<p>(I) Existing cultural resources</p>	<p>McEvoy proposal:</p> <ul style="list-style-type: none"> • Cistern – the existing cistern in the cellar of the parsonage seems to be integral to the building’s support and foundation and will be preserved. The build out of the new addition to the north side of the building is partly for this reason. • Landscape – the existing driveway is asphalt and will be extended the length of the new construction. Many mature trees will have to be removed for the new addition and garage, but tree removal will be limited to only what is needed for the building footprints and to prevent trees from overhanging the buildings. • Stone walls –The McEvoy’s expressed an interest in repurposing the stones from the rubble foundation of the existing barn and passageway to restore the perimeter stonewalls (boundary walls). • Stone well – there may, or may not, be an old stone well off the south side of the house, but it is not in the construction zone and will not be impacted. No indication that a previous cesspool with stone cistern exists anywhere. <p>HDC discussion:</p> <ul style="list-style-type: none"> • Stone walls on the property perimeter, which delineate th

PARTIAL LEFT SIDE ELEVATION GARAGE
SCALE: 3/8" = 1'-0"

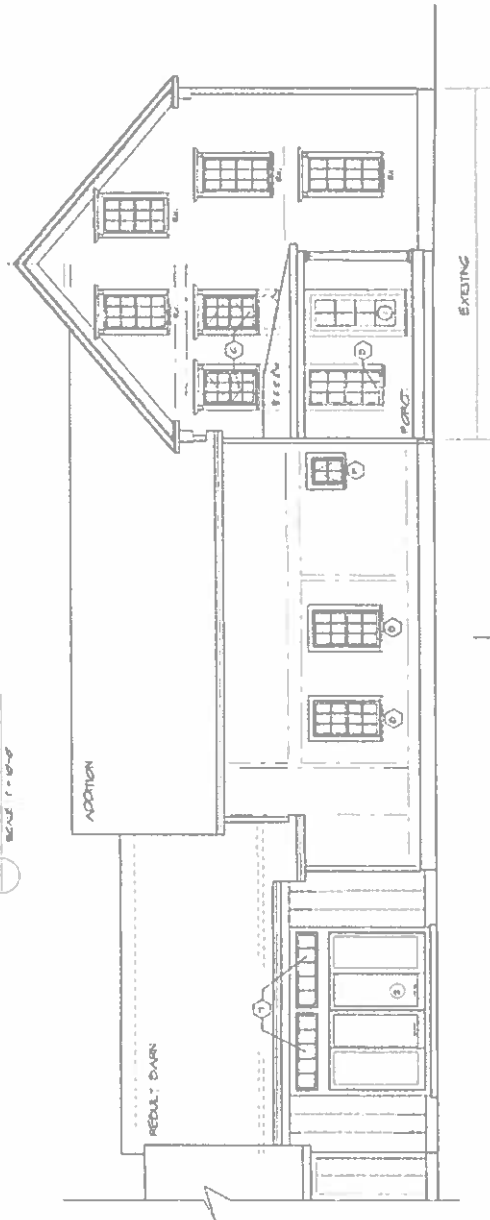
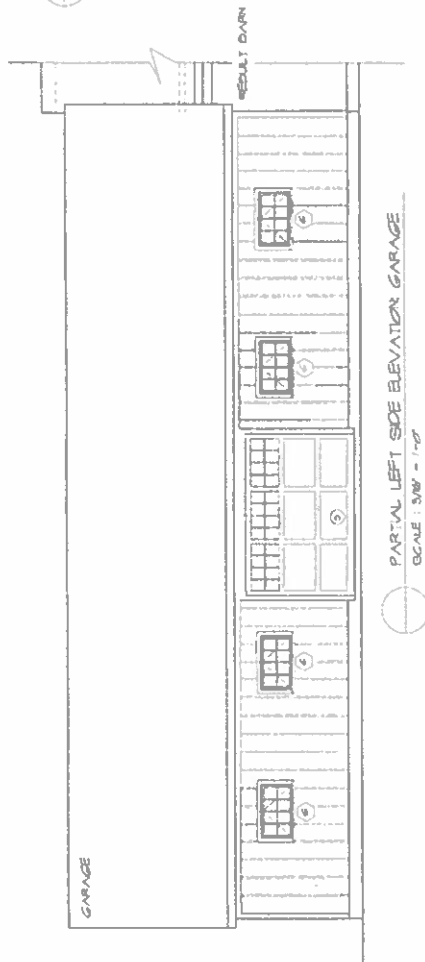
- HDC members thought such a large garage was out of place for an historic district and old parsonage. A commercial company cannot build a business in the residential/historic districts, but the town's zoning does allow home businesses. The proposed garage looks industrial/commercial in appearance, similar to a firehouse or rental storage unit with multiple identical doors. The scale of the garage's parking and entrance/egress requirements is also large. The number of doors and bays was questioned, and the use of at least some sliding doors instead, like those on the barn rebuild, was proposed.
- HDC made suggestions on what could make the existing design more appropriate for an historic setting.
- A potential future solar panel array on the garage roof is noted in the design but is not part of the current proposal or HDC review.

- The goal is to capture detail elements of a carriage shed to obscure the industrial/commercial look of a long garage with five doors/units.

- The McEvoy's will use (1) 45-degree openings at the top of the garage door openings, (2) add a large cupola or windvane structure on the roof, (3) modify two of the garage doors to a different appearance, (4) add appropriate historic lighting between the doors, and (5) build at least a two-foot overhang along the length of the garage door elevation, similar to, but does not have to be a clone of the overhang on the horsesheds.
